NP-11-0035
August 4, 2011

Subject: Exelon Nuclear Texas Holdings, LLC
Victoria County Station Early Site Permit Application
Response to Request for Additional Information Letter No. 09
NRC Docket No. 52-042

RAI 02.05.01-5:**Question:**

RAI 02.05.01-12:**Question:**

Figure 1. Location of Cross Sections and Profiles

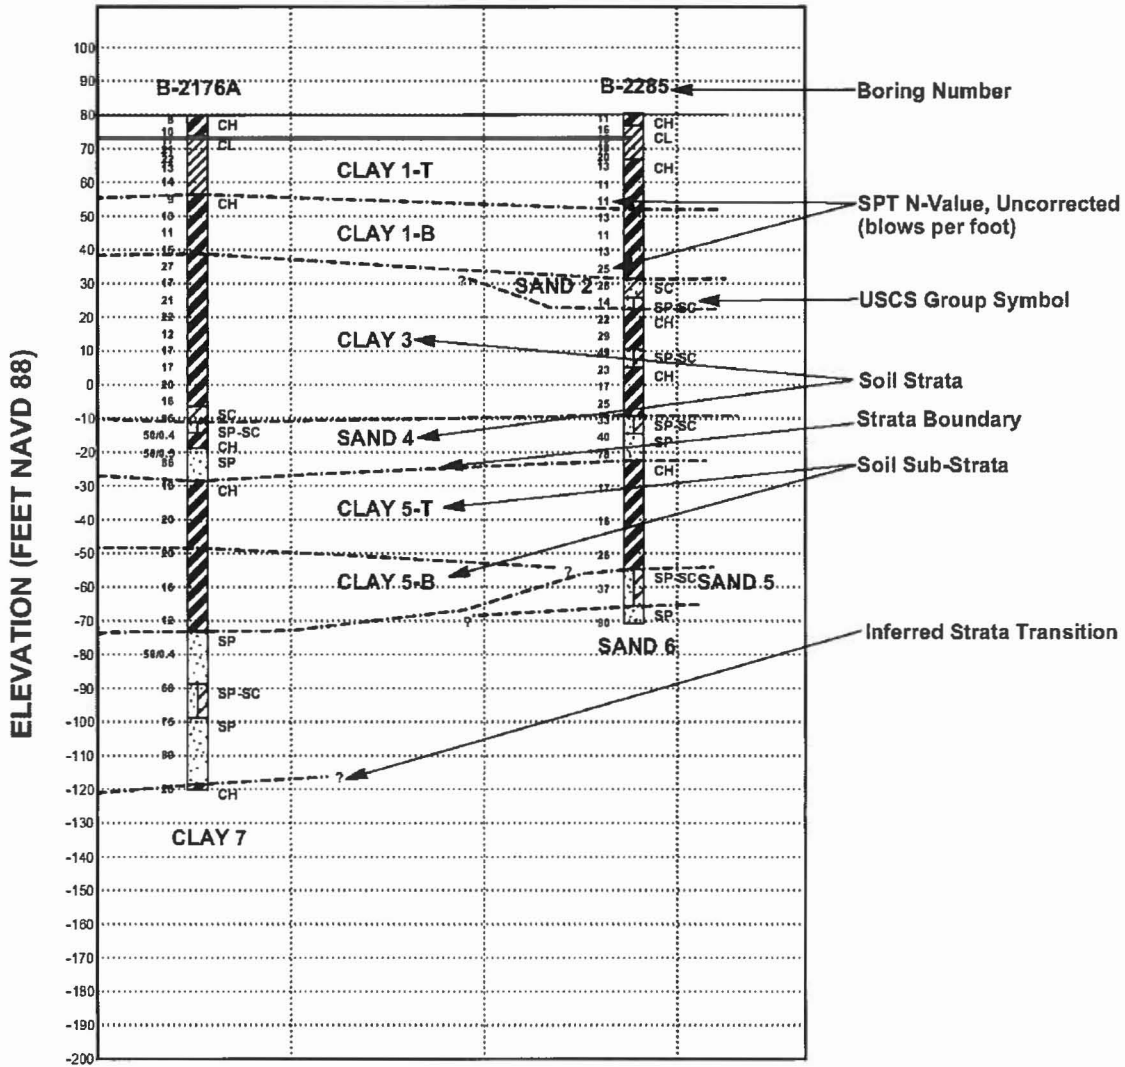
- a. In support of 10 CFR 100.23(d)(2), and in order for the staff to evaluate the shallow subsurface units with respect to the presence (or lack thereof) of the fault, please develop cross-sections orthogonal to the trace of the fault and reevaluate the data to determine if there is an indication of a fault in the shallow subsurface.

The locations of the cross sections (X-X', Y-Y', W-W', and Z-Z') and profiles (E, F, and G) are shown in Figure 1. The explanation of the lithologies in the cross sections and profiles is shown as a legend in Figure 2. Cross sections X-X' and Y-Y' (Figures 3 and 4) were developed from the cross sections shown in SSAR Figures 2.5.1-34 and -35 while profiles E, F, and G (Figures 7, 8, and 9) were developed from the profiles shown in SSAR Figures 2.5.4-14, -15, and -16. Cross sections W-W' and Z-Z' (Figures 5 and 6) are new cross sections. With the exception of cross section X-X', all of the cross sections and profiles show the detailed stratigraphy beneath the site,

Figure 3. X-X' Cross Section

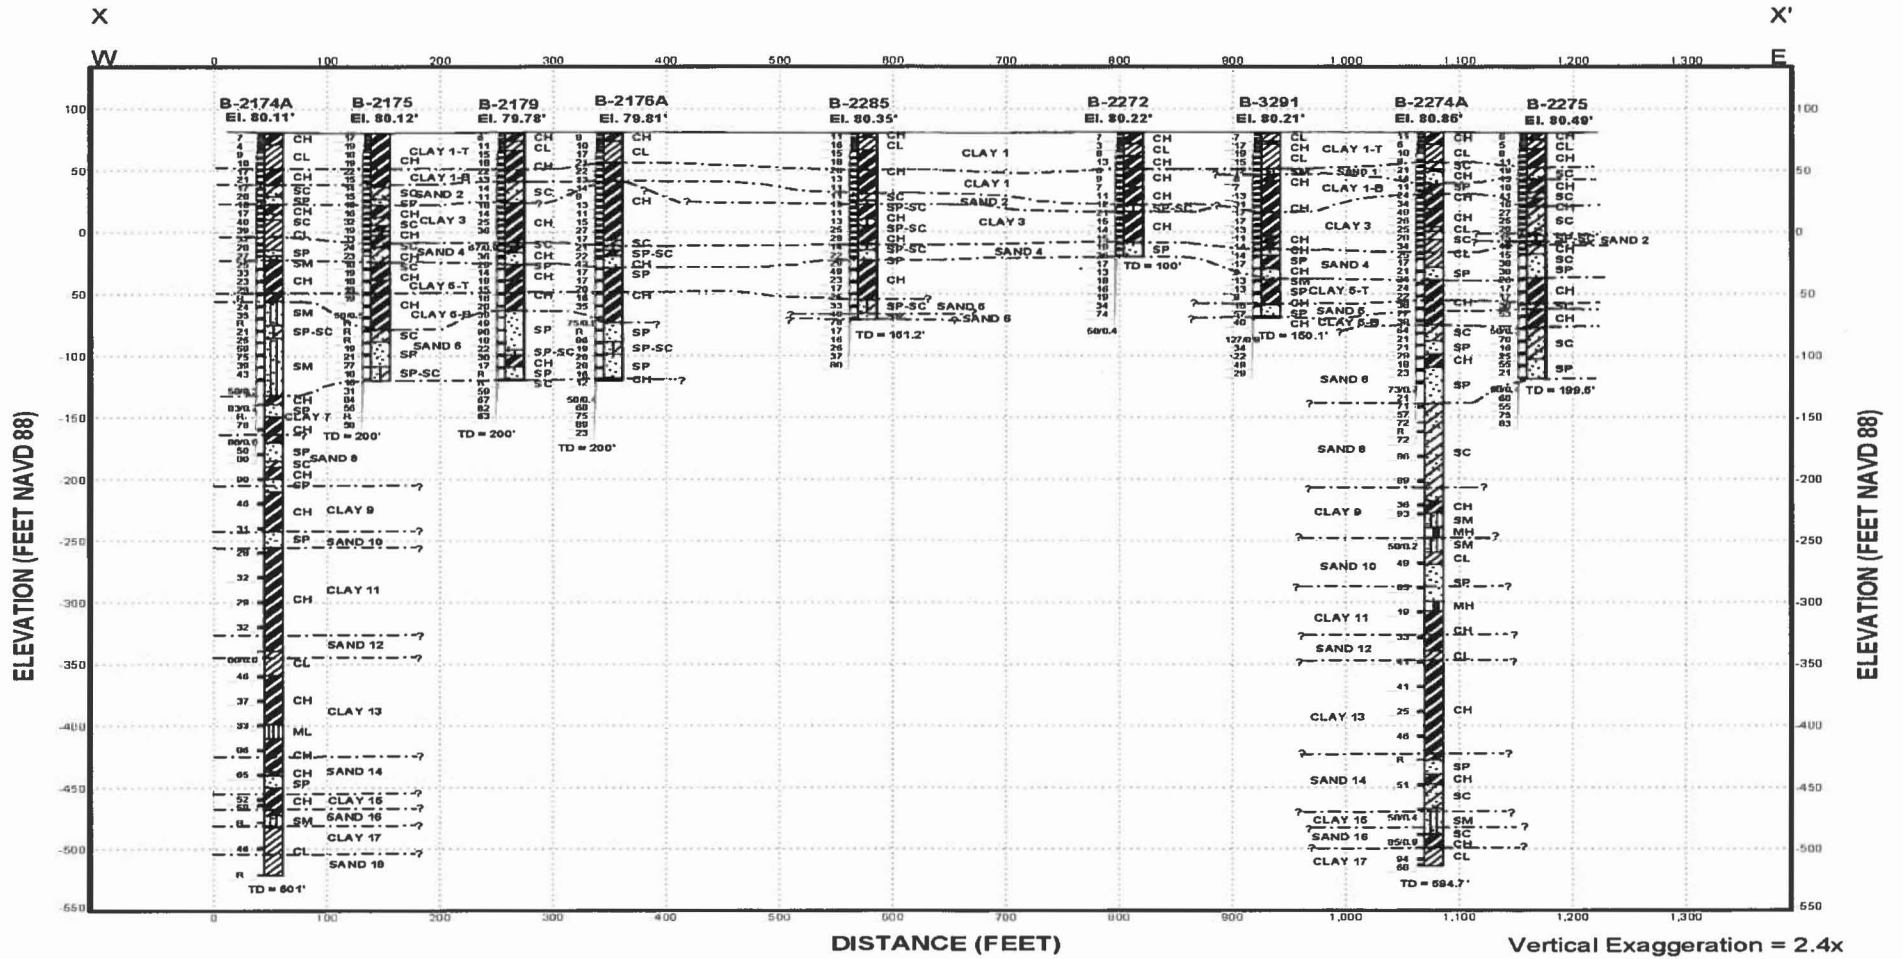
In SSAR Section 2.5 there are several cross-sections of shallow subsurface borehole data: Figures 2.5.1-34 and 35, and 2.5.4- 14, -15, and -16. For example, Fig. 2.5.4-14 shows a gentle step in topography and apparent offset of the Sand 1 / Clay 1-B contact between boreholes B-2302A and B-2308, which straddle the mapped trace of fault D.

Please add the following on all cross-section figures: stratigraphic or lithologic contacts (e.g. as shown in Figure 2.5.1-34); surface topography based on LiDAR; location of caliche layers; and location of fault(s). Also provide an explanation of the lithologic strip log.

The LiDAR-derived topography data shown on the cross sections and profiles described above does not suggest that there is displacement or offset of the shallow soil strata underlying the site. That is, there appears to be no correlation between surface topography and irregular soil strata contacts. The gentle topographic slope between borings B-2302A and B-2303A shown in Profile E in Figure 7 appears to reflect the slope of the surface of the Beaumont Formation. The Sand 1/Clay 1-B contact is interpreted to be a distributary channel centered along boring B-2308 and flanked by overbank deposits and clay flats. This interpretation is preferred to a fault offset because the down-to-the-south sense of displacement is contradicted by the rise in the underlying Clay 1-B/Sand 2 contact. Cross sections W-W' and Z-Z' shown in Figures 5 and 6, respectively, also show gently dipping strata in the envelope of the potential zone of deformation, inferred to be distributary channel or overbank deposits, while the remaining cross sections and profiles generally show planar soil strata.

Figure 1. Location of Fault E LiDAR Profiles.

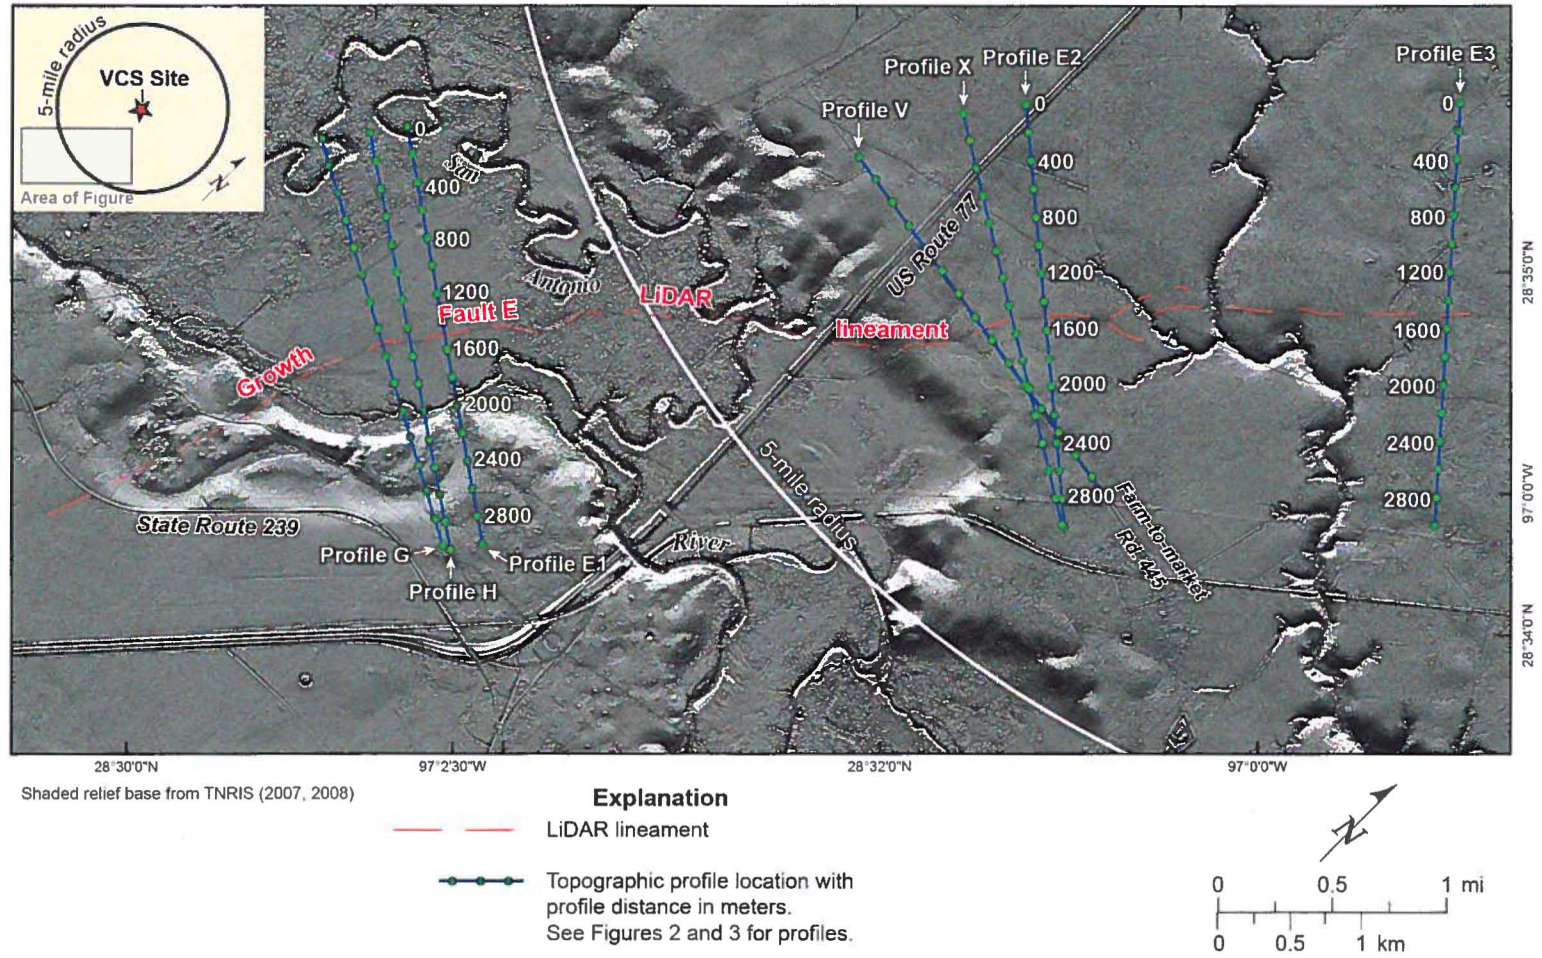
1. Present and compare topographic profiles of the fault E lineament in Beaumont, Holocene, and historic-aged deposits that document along-strike variations in fault topographic profile size and morphology. Discuss the implications of these comparisons for the age of initiation of fault E.
2. Discuss evidence for historical activity on faults D and E in light of recent public report that indicates growth fault E offsets pavement 8 inches on McFaddin Rd where the LiDAR lineament crosses this roadway.
3. Provide a re-evaluation of the rate of movement on fault D in light of these concerns and observations.
4. Compare these rates to published rates from other active growth faults in the region such as those in the Houston area.

Figures 1 through 3 illustrate seven topographic profiles across growth fault E that crosses historic fill along FM Road 445 (called McFaddin Road in the RAI above), Holocene deposits, and Pleistocene deposits. Figure 1 shows the map view of the LiDAR lineament associated growth fault E and location of each topographic profile (including stationing along each profile). Figure 2 illustrates three profiles (G, H, and E1) across the LiDAR lineament where it is mapped across the Holocene San Antonio River floodplain (~10,000 year old; see response to RAI 02.05.01-1 for further discussion). Figure 3 illustrates one profile (V) across the FM Road 445 in artificial fill deposits (<100 yrs old) and three profiles (X, E2, and E3) in the Beaumont Formation deposits ($\geq 100,000$ years old) (See SSAR Subsections 2.5.1.2.3. and 2.5.1.2.4.2.3.3 for more details). Profiles E1, E2, and E3 are reproductions from Figure 2 in the response to RAI 02.05.01-11. Profile V was chosen because it is located in the middle of the FM Road 445. The other profiles shown in Figures 2 and 3 were chosen because they represented a subsample of topographic profiles where the LiDAR lineament associated with growth fault E is well-expressed topographically. For example, the LiDAR lineament crosses a small drainage between profiles E2 and E3 and splits into three different splays. Topographic profiles across this area do not show a well-resolved lineament, and therefore are not useful in a discussion of the age of initiation of growth fault E.
